CHANGE ORDER

Project: Woodland High School Project No.: 1119.00-12
 Architect: McGranahan Architects Change Order No.: 3
 Contractor: Skanska USA Building, Inc. Date: March 12, 2014

Reference: S10.4/7, detail at canopy edge. A4.12/6 and A4.12/10.

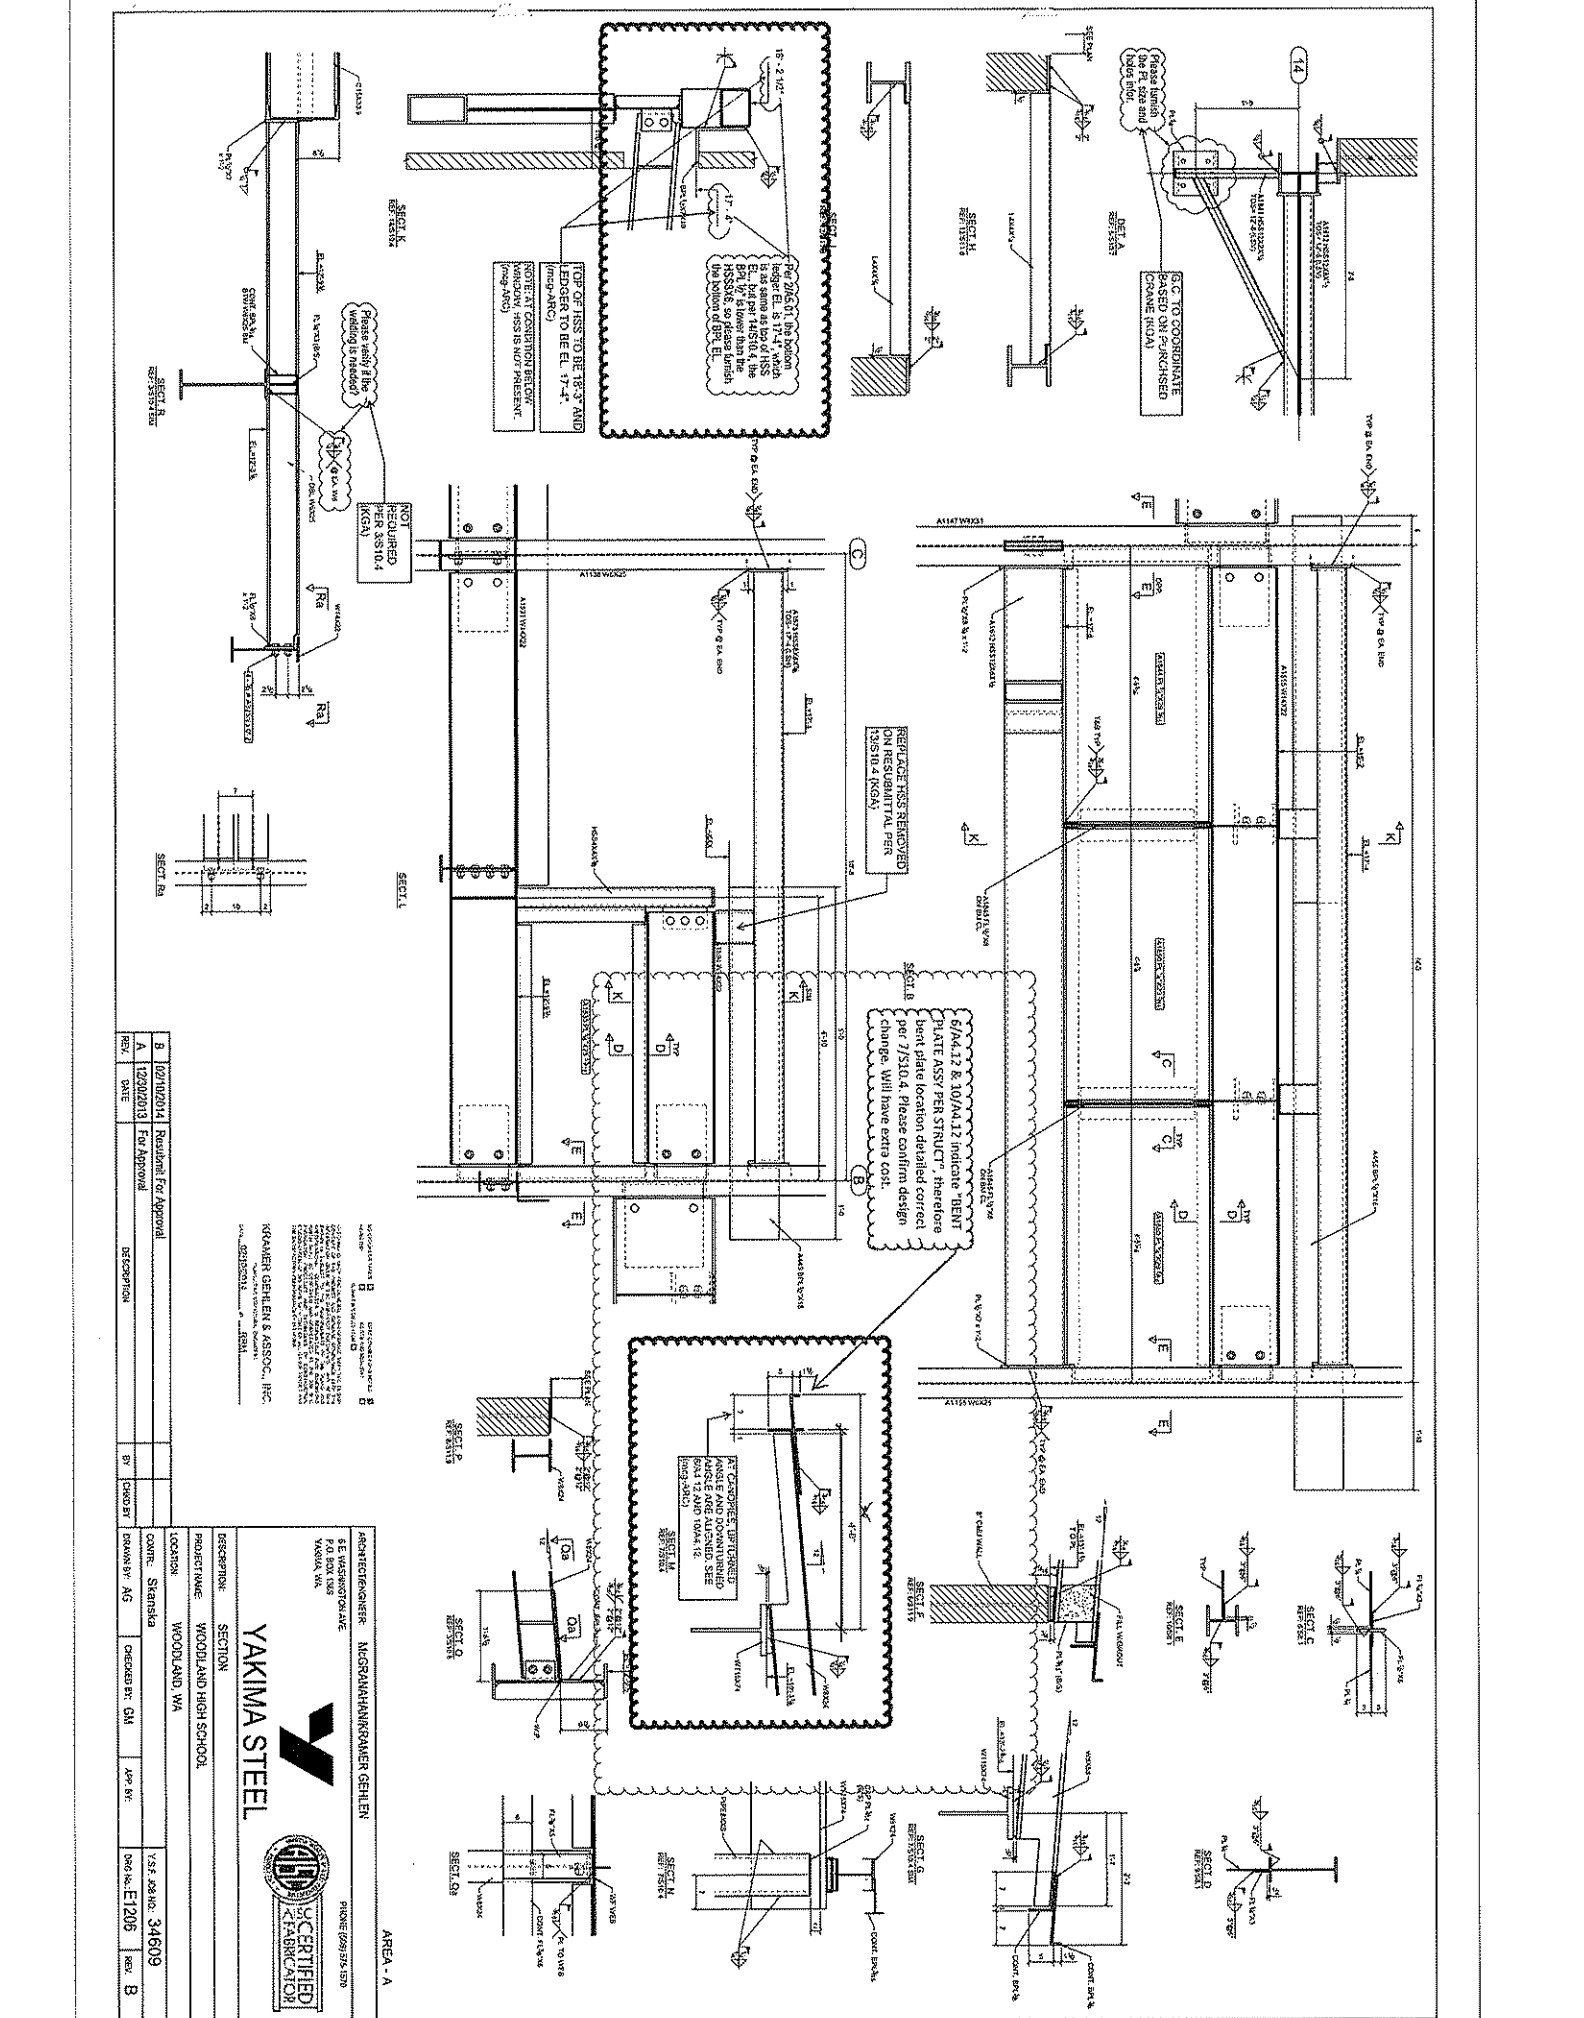
Architectural detail 6 & 10/A4.12 indicated "bent plate assy per structural", therefore the bent plate was located per detailed S10.4/7. Please confirm bent plate location.

WOODLAND HIGH SCHOOL		1119.000	McGRANAHAN architects	311 E 343.3097 312 T 343.3084
TITLE		LEVEL 2 - HVAC PLAN - MECHANICAL 2409D DUCT REVISION		
REFERENCE	11/14/23			
SCALE	AS INDICATED			
ISSUED FOR:	RPI-084			
DATE	02/17/24			
		MSK - 084		
		REVISER:		
		DRAWN BY:	PD

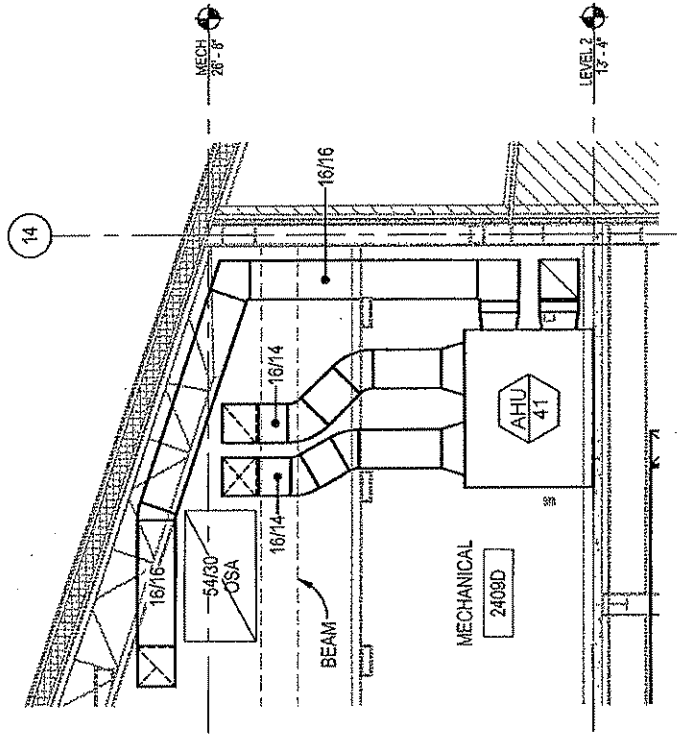
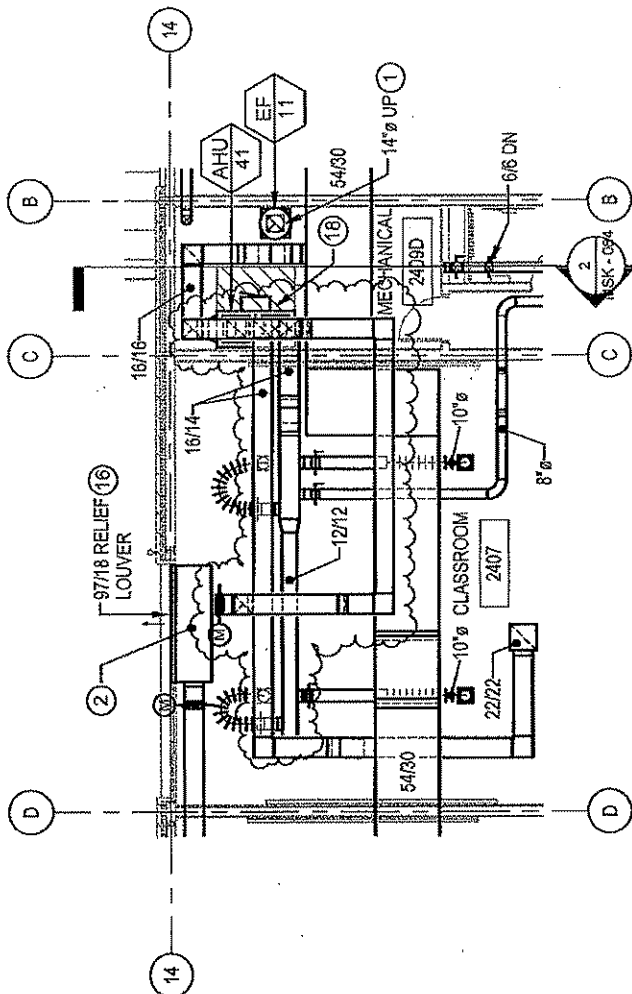
During the MEP coordination, clashes were identified between ductwork and mechanical pipe in mechanical room 2409D. It was discovered that due to the structural steel and the ceiling elevation of room 2407, there is no route for the duct below the steel.

Possible solution: Install a soffit along the east wall of classroom 2407 to accommodate the duct work entering and leaving the mechanical room 2409D. Soffit should have a finish elevation of 8'-2" to allow for the duct connection and framing, and should have a 20" clear space from the east wall of room 2407.

Revise ductwork at AHU-41 as indicated in sketch MSK-084. The south classroom wing has a similar condition, revise ductwork at AHU-1 as indicated on sketch MSK-085.
